Access Compliance Report

Public Rights-of-Way

(Curb Ramps)

Intersection ID: 10541	Main Street: CANTON_PL	Cross Street: POLK_ST	Location: SW
ADA ID: D721835D6B56	Ramp Type: Combination1	Initial Pass/Fail: Fail	Overall Compliance: No
Codes/Mitigation Info/Possible Solution		Field Measurements/Component Compliance	
Severity Score: 22.5

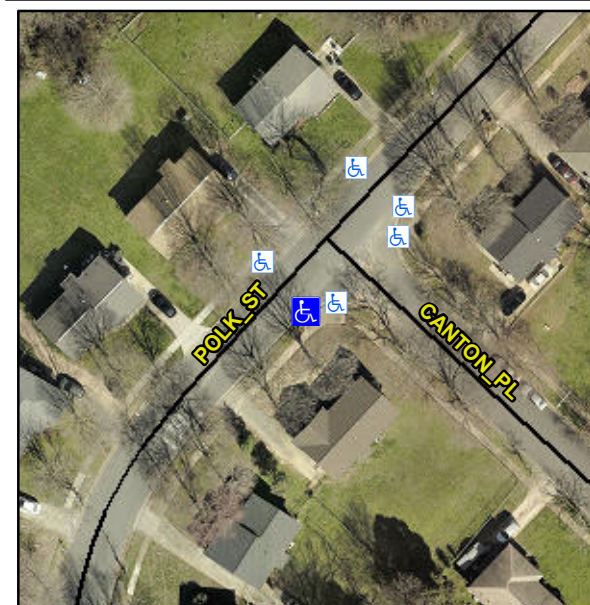
LT RP < 5%

**Not Found, R304.5.1, R304.5.3,
R304.3.2**

Compliance	Description	Data	Compliance	Description	Data
N/A	Ramp Length LT (in)	35.0	N/A	Ramp Length RT (in)	38.5
No	Ramp Width LT (in)	46.0	Yes	Ramp Width RT (in)	48.0
Yes	Ramp Slope LT (%)	3.6	No	Ramp Slope RT (%)	8.5
No	Ramp XSlope LT (%)	3.7	Yes	Ramp XSlope RT (%)	1.1
N/A	Ramp Length (in)	65.0	Yes	Ramp Slope (%)	7.4
Yes	Ramp Width (in)	48.0	Yes	Ramp XSlope (%)	2.3
N/A	Flare Type LT	N/A	N/A	Flare Type RT	N/A
N/A	Flare Slope LT (%)	N/A	N/A	Flare Slope RT (%)	N/A
N/A	Flare Traversable LT?	N/A	N/A	Flare Traversable RT?	N/A
N/A	Landing Length (in)	N/A	N/A	DWS Provided?	N/A
N/A	Landing Width (in)	N/A	N/A	DWS Contrast?	N/A
N/A	Landing Slope (%)	N/A	N/A	DWS Length (in)	N/A
N/A	Landing X Slope (%)	N/A	N/A	DWS Full Width?	N/A
N/A	Landing Curb? (Y/N)	N/A	N/A	DWS Offset (in)	N/A
N/A	Shared Landing?	N/A			
N/A	Gutter Ponding?	N/A	N/A	Gutter Slope (%)	N/A
N/A	Gutter Lip Ht (in)	N/A	N/A	Gutter X Slope (%)	N/A
N/A	Painted X Walk1?	No	N/A	Painted X Walk2?	N/A

**Remove & Replace Entire Ramp.
Remove & Replace Sidewalk.**
